Groundwater Application Review Summary Form

Application # G- 18519

PUBLIC INTEREST REVIEW FOR GROUNDWATER APPLICATIONS

TO: Water Rights Section Date 08/16/2017
 FROM: Groundwater Section Dennis Orłowski
 SUBJECT: Application G- 18515 Supersedes review of _____
 Reviewer's Name
 Date of Review(s)

D1. Well #: 2 Logid: CLAC 72276

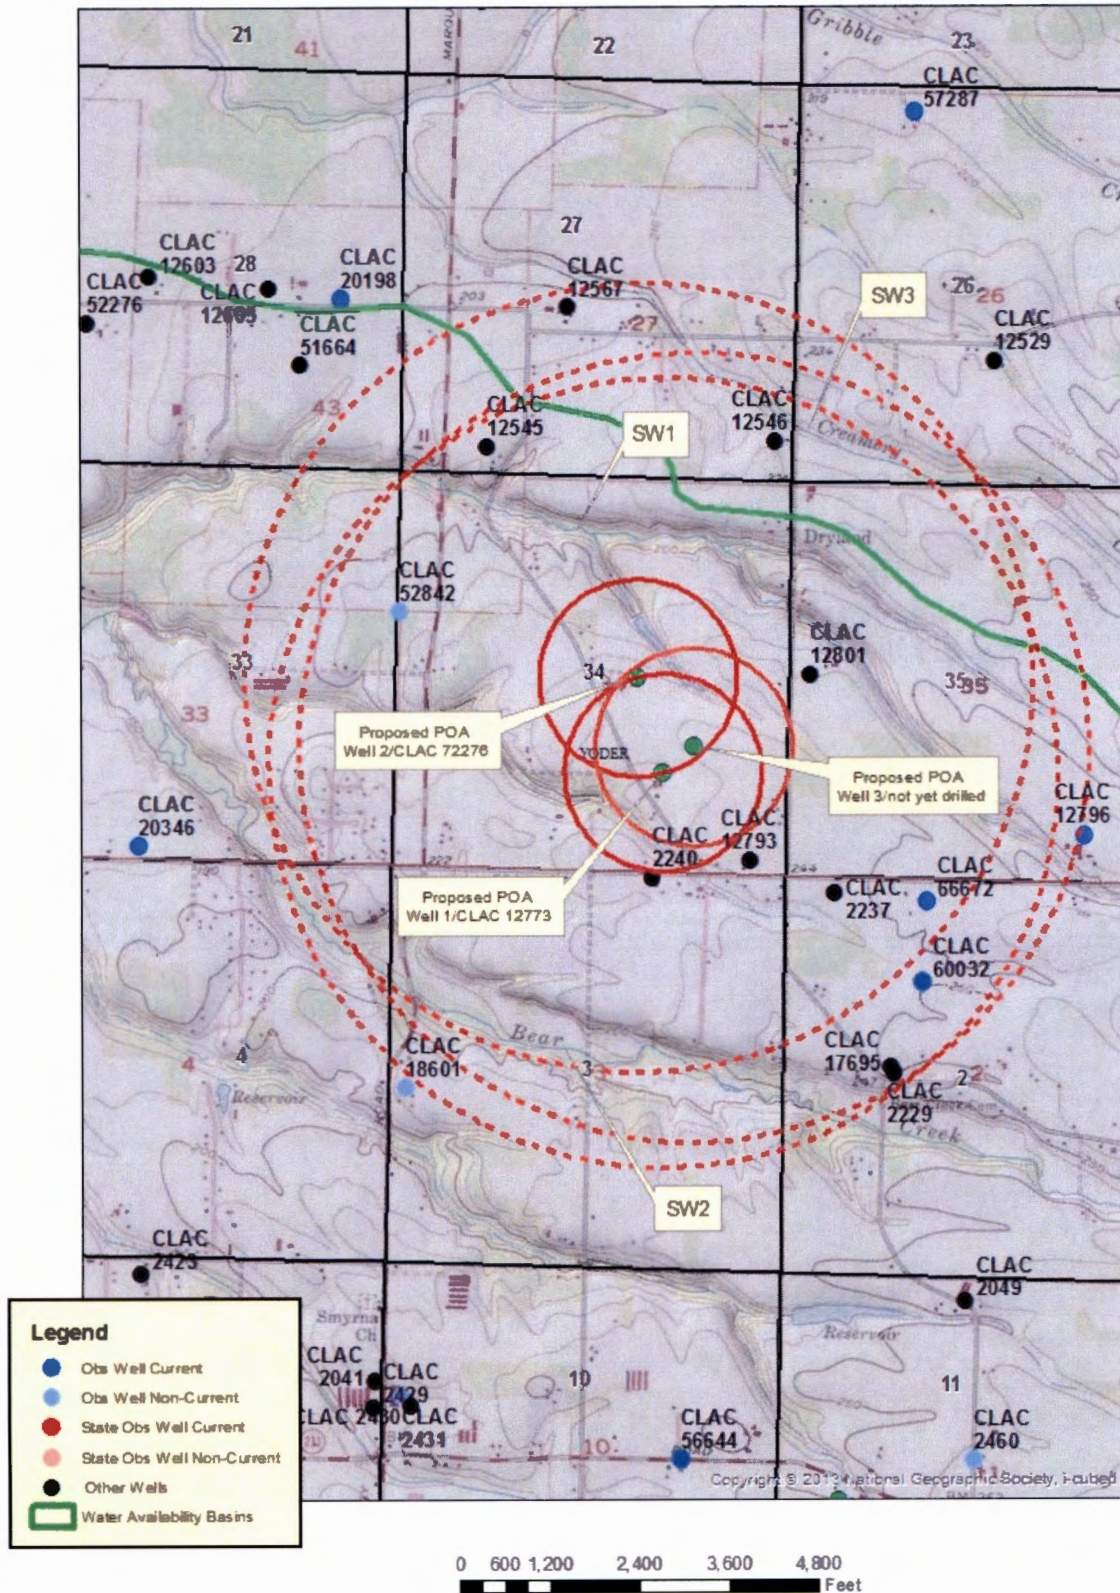
D2. **THE WELL does not appear to meet current well construction standards based upon:**

- a. ☒ review of the well log;
- b. ☐ field inspection by _____;
- c. ☐ report of CWRE _____;
- d. ☐ other: (specify) _____

D3. **THE WELL construction deficiency or other comment is described as follows:** The log for Well 2, CLAC 72276, does not indicate the presence of a surface seal.

D4. ☒ **Route to the Well Construction and Compliance Section for a review of existing well construction.**
